Reliability Analysis Update

Transmission Expansion Advisory Committee

May 9, 2023

Changes to Existing Projects

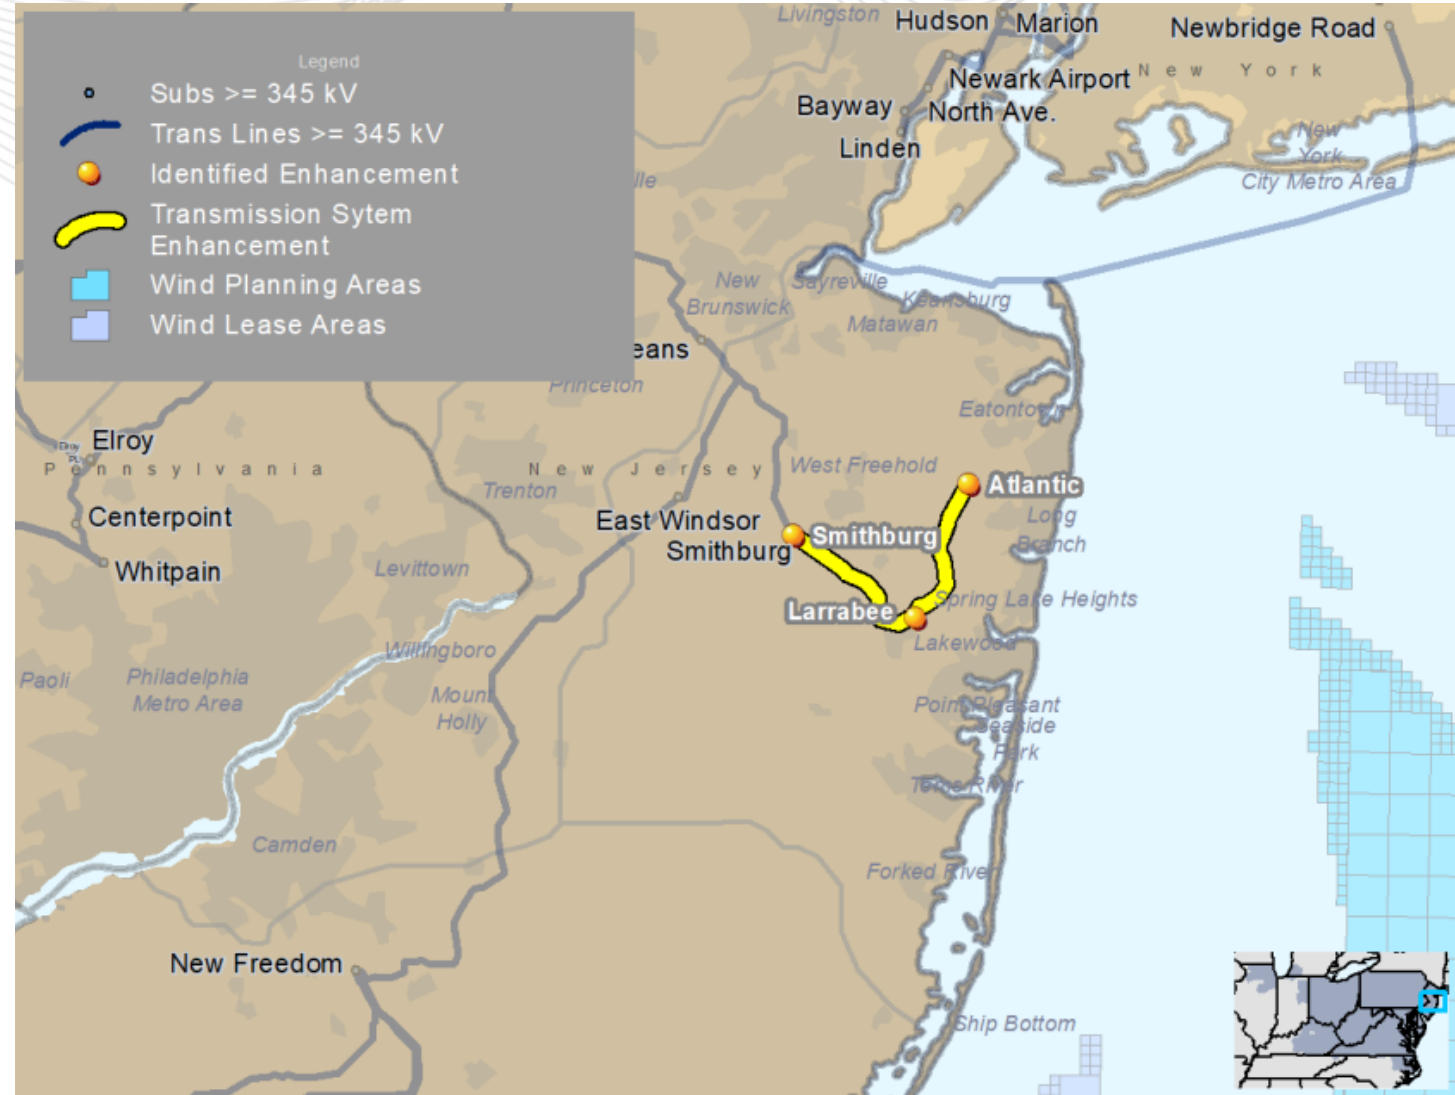
- Larrabee Collector Station-Smithsburg No. 1 500 kV line (new asset). New 500 kV line will be built double circuit to accommodate a 500 kV line and a 230 kV line. (b3737.6) - \$150.35 M
- Rebuild G1021 Atlantic-Smithsburg 230 kV line between the Larrabee and Smithsburg substations as a double circuit 500kV/230kV line (b3737.7) - \$62.85 M
- Smithsburg substation 500 kV expansion to 4 breaker ring (b3737.8) - \$68.25 M
- Rebuild Larrabee-Smithsburg No. 1 230 kV (b3737.32) - \$44.77 M
- Remove the existing E83 Line 115 kV (not in-service) to accommodate the new 500kV/230kV lines (approximately 7.7 miles) (b3737.53) - \$8.47M
- Remove the existing H2008 Larrabee-Smithsburg No. 2 230 kV to accommodate the new 500kV/230kV lines (b3737.54) - \$8.47 M

Estimated Cost (b3737.1-.21 & .32 & .53-.54): ~~\$427.82 M~~ \$444.76 M

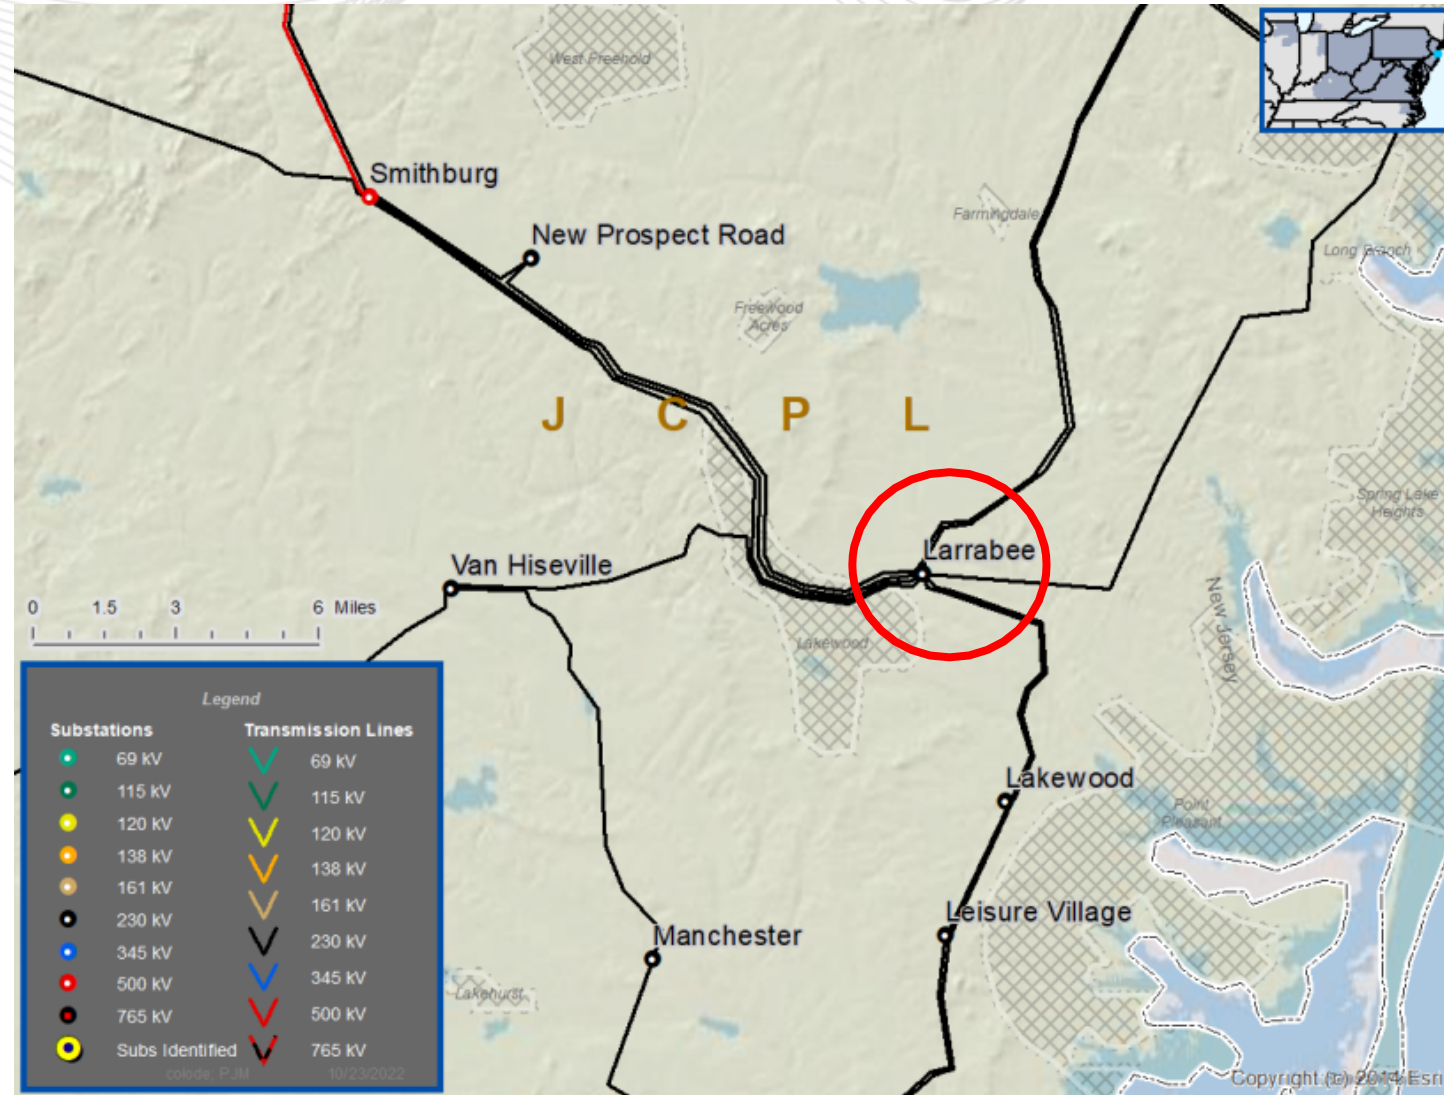
- Construct the Larrabee Collector Station AC switchyard, composed of a 230 kV 3 x breaker and a half substation with a nominal current rating of 4000 A and four single phase 500/230 kV 450 MVA autotransformers to step up the voltage for connection to the Smithburg substation.
- Procure land adjacent to the AC switchyard, and prepare the site for construction of future AC to DC converters for future interconnection of DC circuits from offshore wind generation. Land should be suitable to accommodate installation of 4 individual converters to accommodate circuits with equivalent rating of 1400 MVA at 400 kV. (b3737.22)

Estimated Cost (b3737.22): ~~\$121.10 M~~ **\$193.3 M**

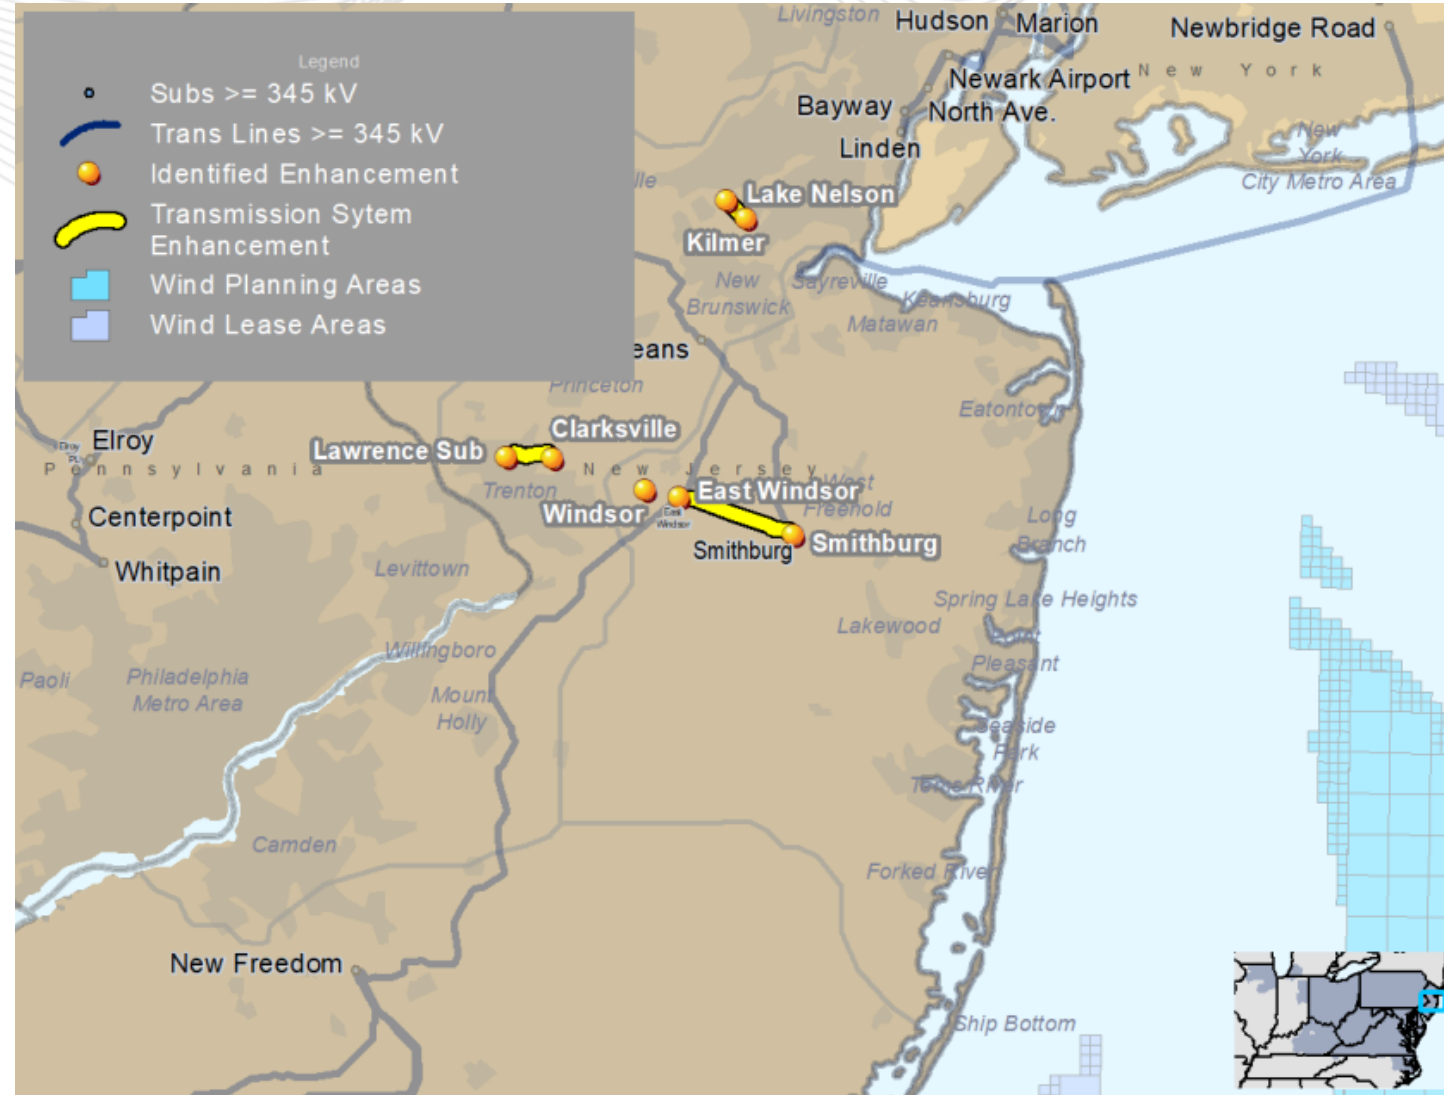
- Rebuild approximately 0.8 miles of the D1018 (Clarksville-Lawrence 230 kV) line between Lawrence substation (PSEG) and structure No. 63 (b3737.27) - ~~\$11.45 M~~ **\$14.58M**
- Reconductor Kilmer I-Lake Nelson I 230 kV (b3737.28) - \$4.42 M

Estimated Cost (b3737.27-.30): ~~\$235.75 M~~ **\$238.88 M**

JCPL Transmission Zone: Baseline NJ SAA Project

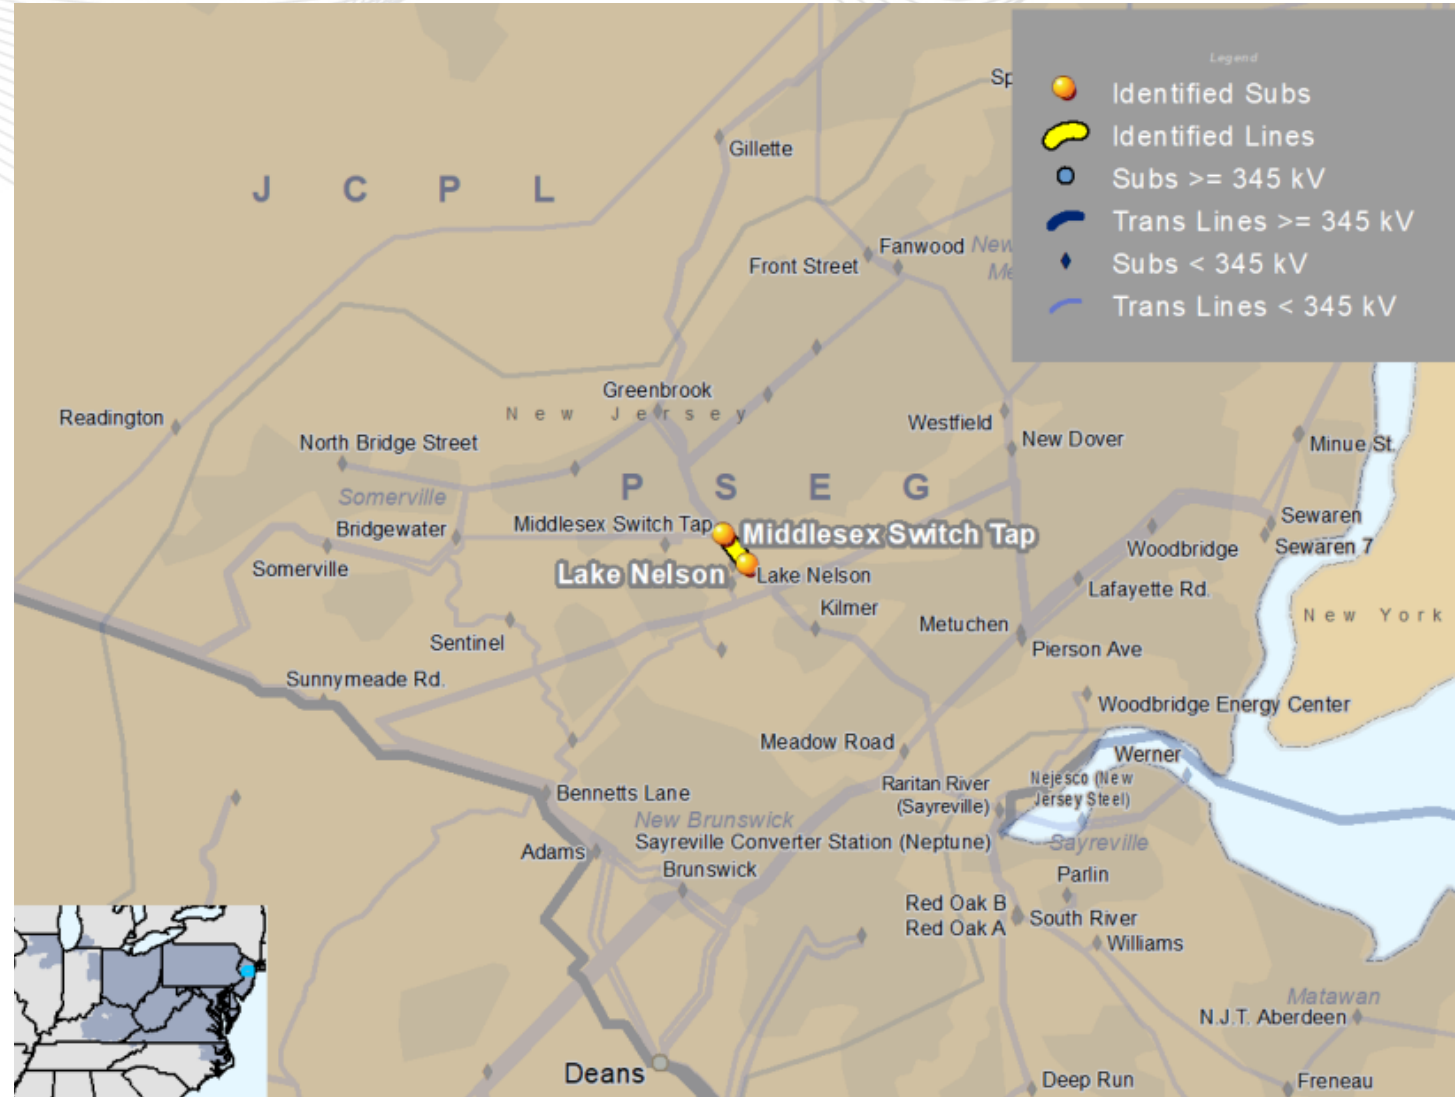
- Additional reconductoring required for Lake Nelson I-Middlesex 230 kV (b3737.31) - \$3.3 M
- **Middlesex Substation 230kV - Replace the 2000A Circuit Switcher at Middlesex Switch point for the Lake Nelson I1023 230kV exit (b3737.55) - \$0.53 M**

Estimated Cost (b3737.31): ~~\$3.3 M~~ **\$3.83 M**

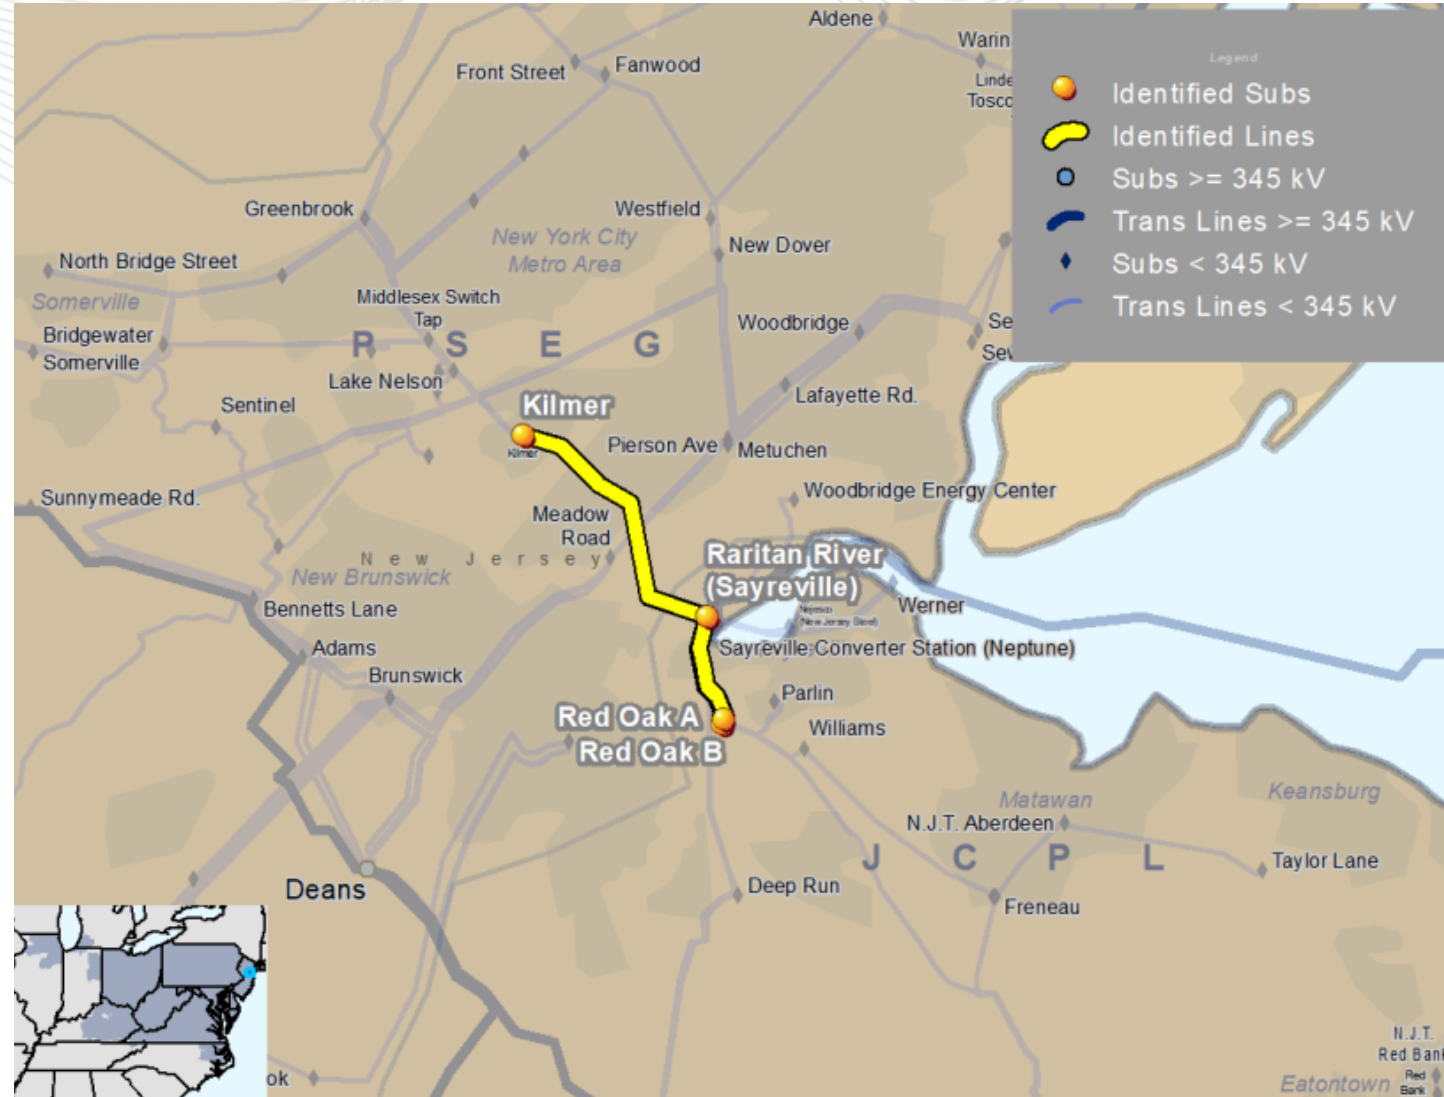
- Reconductor Red Oak A-Raritan River 230 kV (b3737.33) - ~~\$11.05 M~~ **\$12.53 M**
- Reconductor Red Oak B-Raritan River 230 kV (b3737.34) - \$3.9 M
- Reconductor small section of Raritan River-Kilmer I 230 kV (b3737.35) - ~~\$0.2 M~~ **\$27.3 M**
- Replace substation conductor at Kilmer and reconductor Raritan River-Kilmer W 230 kV (b3737.36) - \$25.88 M

Estimated Cost (b3737.33-.36): ~~\$41.03 M~~ **\$69.61**

PSEG & JCPL Transmission Zone: Baseline NJ SAA Project

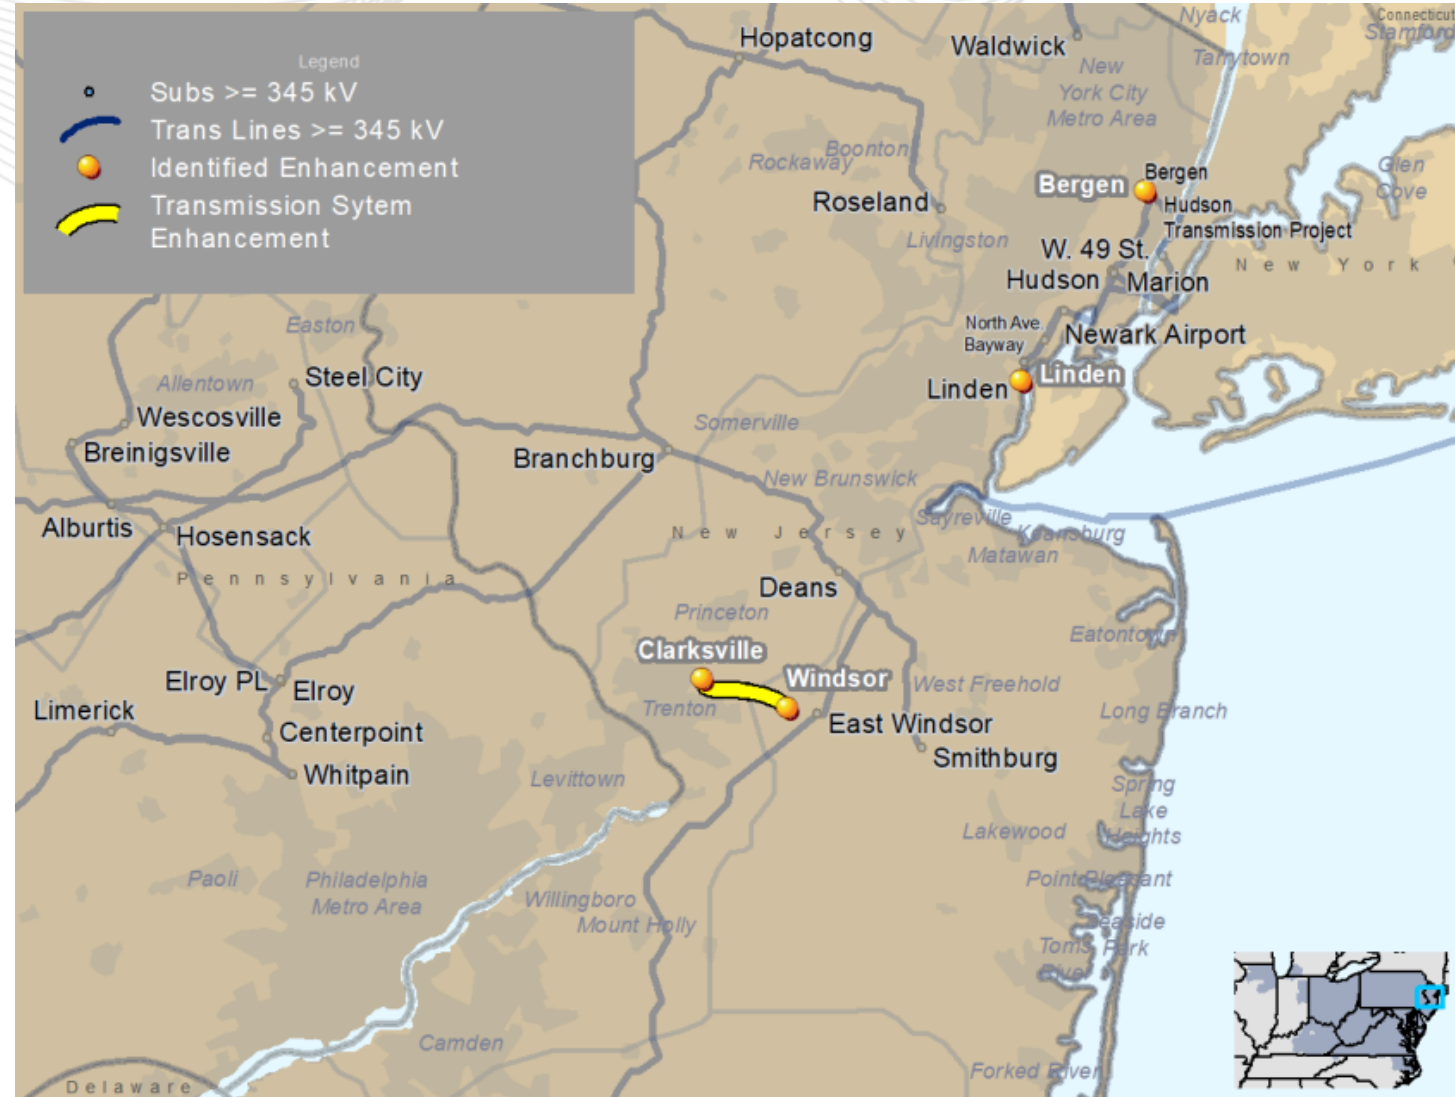
- Linden Subproject: Install a new 345/230 kV transformer at the Linden 345 kV Switching Station, and relocate the Linden-Tosco 230 kV (B-2254) line from the Linden 230 kV to the existing 345/230 kV transformer at Linden 345 kV (b3737.38) - \$24.92 M **\$35.3 M**
- Bergen Subproject: Upgrade the Bergen 138 kV ring bus by installing a 80 kA breaker along with the foundation, piles, and relays to the existing ring bus, install breaker isolation switches on existing foundations and modify and extend bus work (b3737.39) - \$5.53

- Windsor to Clarksville Subproject: ~~Create a paired conductor path between Clarksville 230 kV and JCPL Windsor Switch 230 kV~~ **Reconductor one span of the C1017 (Clarksville-Windsor) 230kV line from structure #126 to Windsor Substation with double bundled 1590 ACSR conductor, approximately (0.1) mile.** (b3737.40) - \$4.28 M **\$1.72 M**
- Windsor to Clarksville Subproject: Upgrade all terminal equipment at Windsor 230 kV and Clarksville 230 kV ~~as necessary to create a paired conductor path between Clarksville and JCPL East Windsor Switch 230 kV~~ (b3737.41) - \$1.49 M
- **Windsor to Clarksville Subproject: Upgrade terminal equipment at Windsor 230 kV (b3737.59) - \$1.58 M**

Estimated Cost (b3737.38-.41, 59): ~~\$36.22 M~~ **\$45.62 M**
